Onderwerp Mijlpaal Waterveiligheid RvdR Ontpoldering Noordwaard

Onderwerp
Toetsing hydraulische berekeningen voor de Eindontwerp maatregel "Ontpoldering Noordwaard"

**Review of Noordwaard
Eindontwerp hydraulic
computations**

Figure 3.1 Bottom height of As-Built variant WAQUA model.

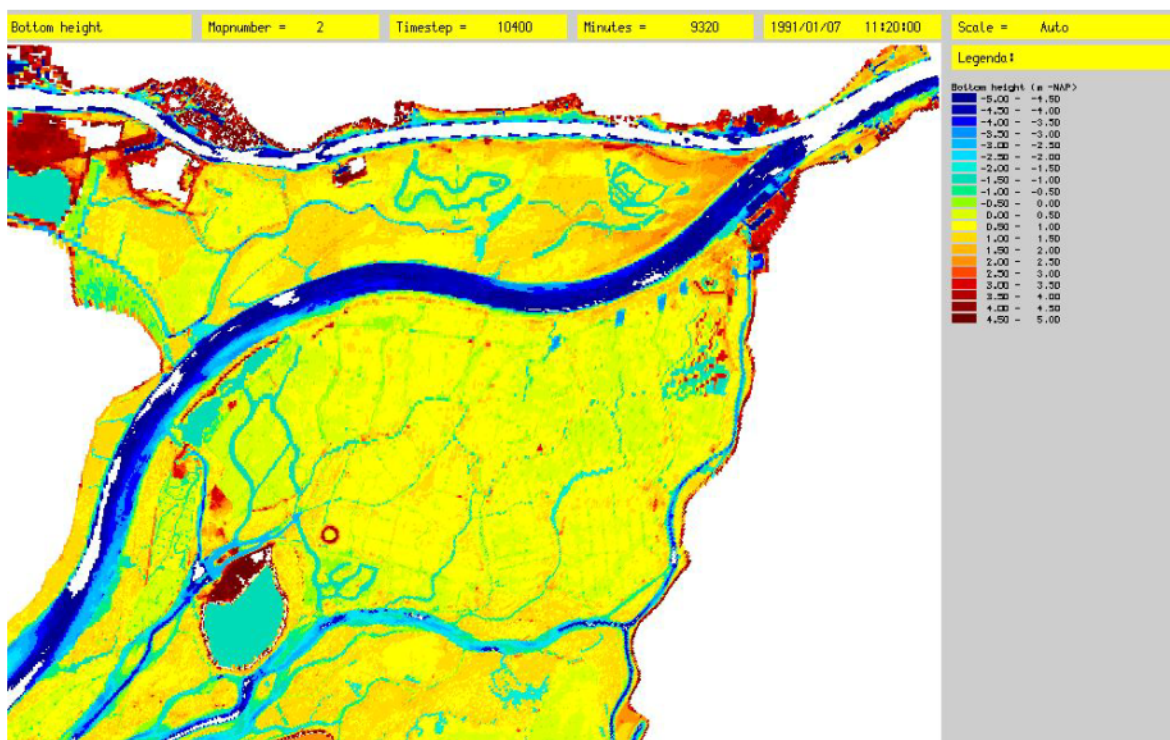
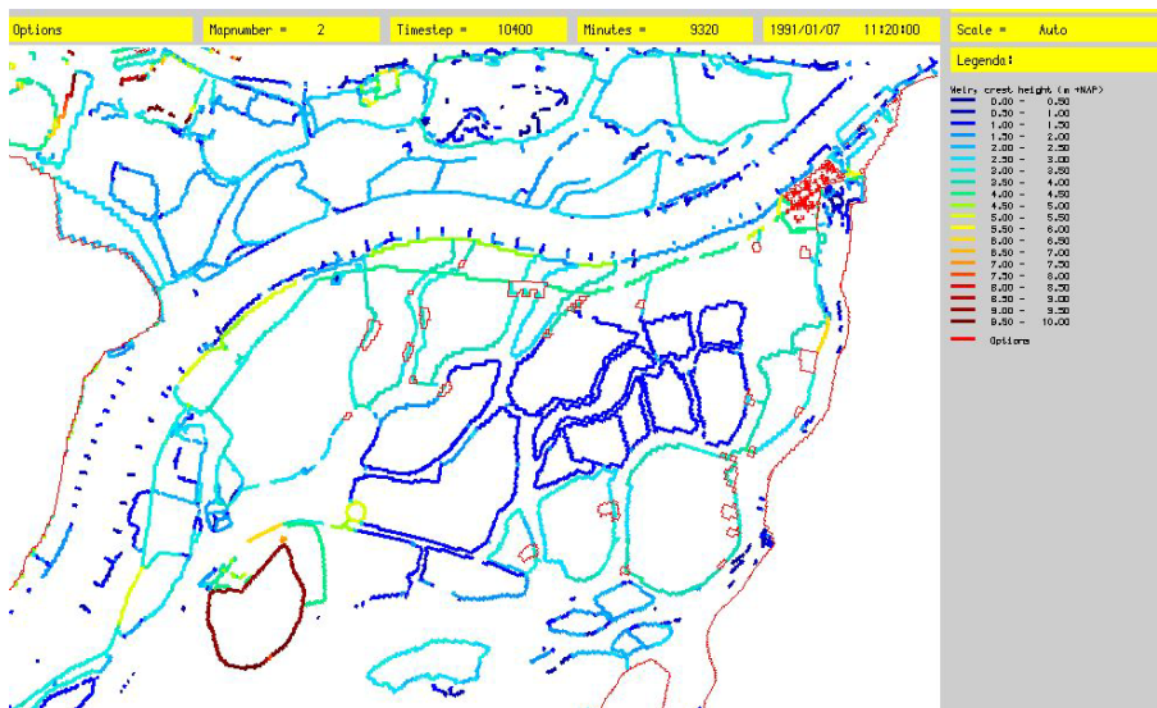
The different aspects of the WAQUA schematization are shown in Figure 3.1 and Figure 3.2. Changes in the variant are a result of the measures.

The creeks are sometimes too small for the used grid. For this project this is not an issue. It is important to keep this limitation in mind if detailed studies in Noordwaard are wished for.

Deltares finds the conversion and schematization of the WAQUA model suitable to perform simulations for the Room for the River project.

Figure 3.3 Difference in height between SNIP3 and Eindontwerp variant

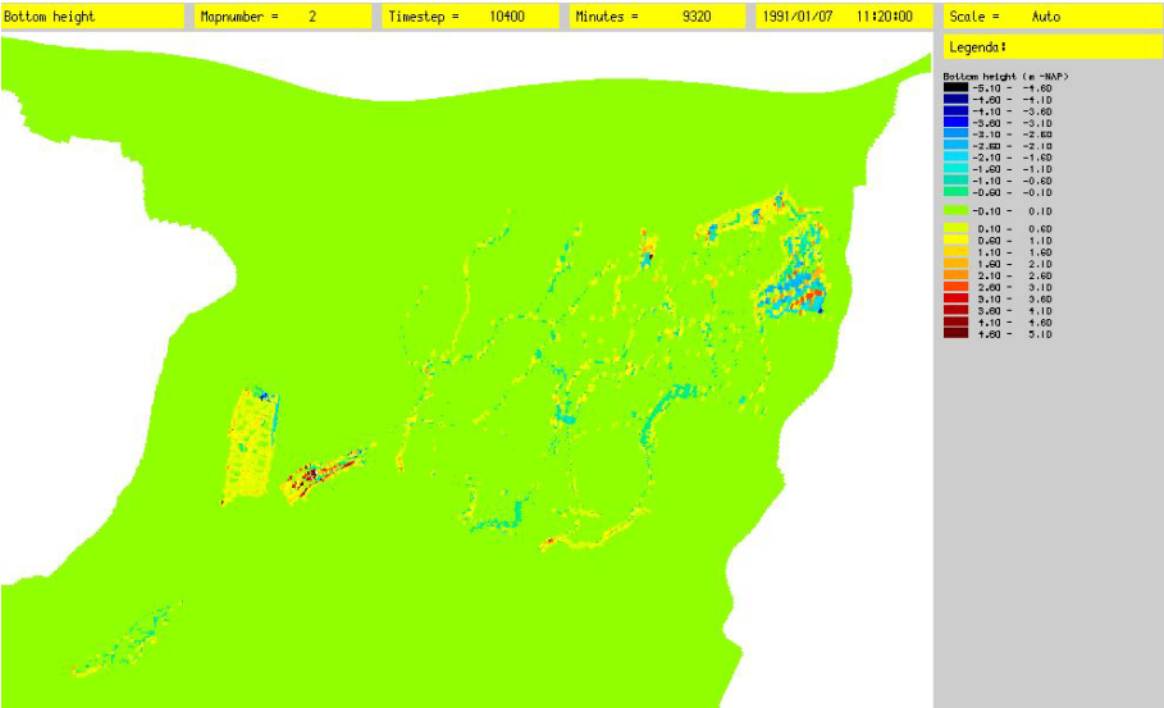
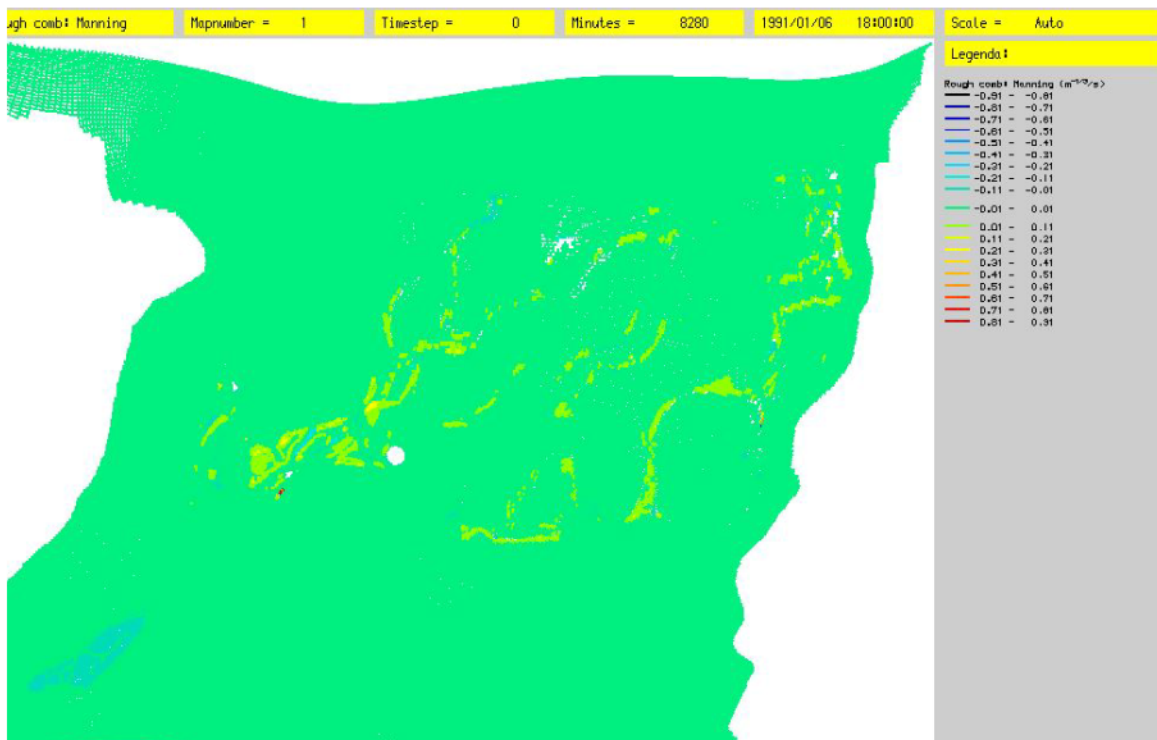
The changes in height compared to the SNIP3 model are only visible in the area adjusted by the contractor (Figure 3.3). These areas are mainly creeks, the area in front of the inlet openings and the Recreatiepoort. Most of the dikes (weirs) are updated in the latest schematization (Figure 3.4). The dikes position has been slightly changed in the current schematisation compared to SNIP3 variant. The roughness is slightly different around the creeks (Figure 3.5).

The changes between SNIP3 and the Eindontwerp variant are a logical consequence of the update of the schematization.

Figure 3.6 Discharge of the variant

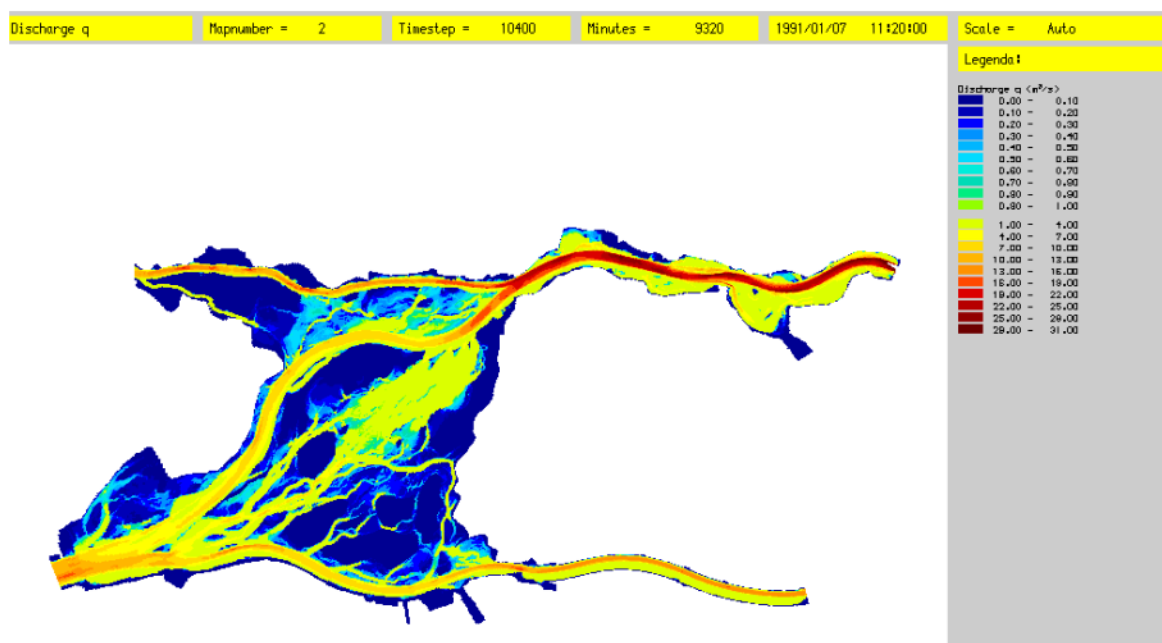
Most of the water will flow via the laagbekade polders in the Noordwaard (Figure 3.6). There is no waterflow between the Spiering and the small Noordwaard. These areas do act as a water storage area.
